# Access Compliance Report

## Public Rights-of-Way

### (Curb Ramps)

Intersection ID: 10036601	Main Street: RUSHMORE_DR	Cross Street: N/A	Location: S
ADA ID: B6B20125C6A5	Ramp Type: PerpDiag	Initial Pass/Fail: Fail	Overall Compliance: No
		Severity Score: 22.5

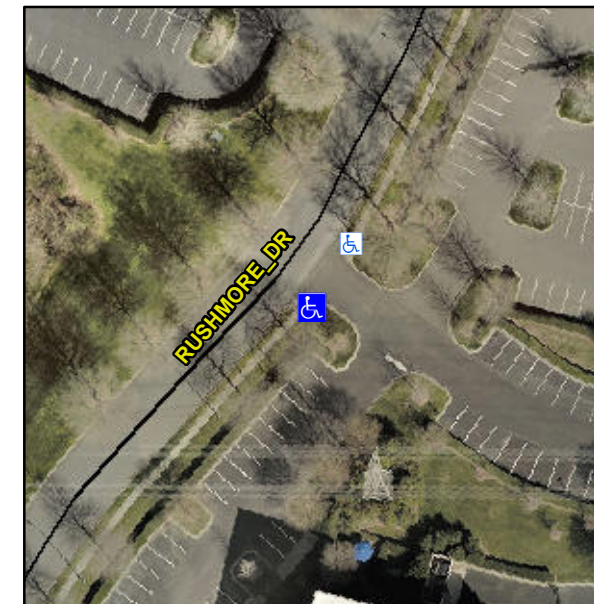
**Not Found, R304.5.1, R304.2.2, R304.5.3**

Compliance	Description	Data	Compliance	Description	Data
N/A	Ramp Length (in)	61.0	No	Ramp Slope (%)	9.2
No	Ramp Width (in)	39.0	No	Ramp XSlope (%)	4.2
N/A	Flare Type LT	N/A	N/A	Flare Type RT	N/A
N/A	Flare Slope LT (%)	N/A	N/A	Flare Slope RT (%)	N/A
N/A	Flare Traversable LT?	N/A	N/A	Flare Traversable RT?	N/A
N/A	Landing Length (in)	N/A	N/A	DWS Provided?	N/A
N/A	Landing Width (in)	N/A	N/A	DWS Contrast?	N/A
N/A	Landing Slope (%)	N/A	N/A	DWS Length (in)	N/A
N/A	Landing X Slope (%)	N/A	N/A	DWS Full Width?	N/A
N/A	Landing Curb? (Y/N)	N/A	N/A	DWS Offset (in)	N/A
N/A	Shared Landing?	N/A			
N/A	Gutter Ponding?	N/A	N/A	Gutter Slope (%)	N/A
N/A	Gutter Lip Ht (in)	N/A	N/A	Gutter X Slope (%)	N/A
N/A	Painted X Walk1?	No	N/A	Painted X Walk2?	No
	X Walk 1 Direction	To NE		X Walk 2 Direction	To NW
N/A	X Walk 1 Width (in)	N/A	N/A	X Walk 2 Width (in)	N/A
	X Walk 1 Slope (%)	0.4		X Walk 2 Slope (%)	2.1
	X Walk 1 X Slope (%)	6.8		X Walk 2 X Slope (%)	1.6

**Remove & Replace Curb Ramp With Two New Directional Ramps or Equivalent.**
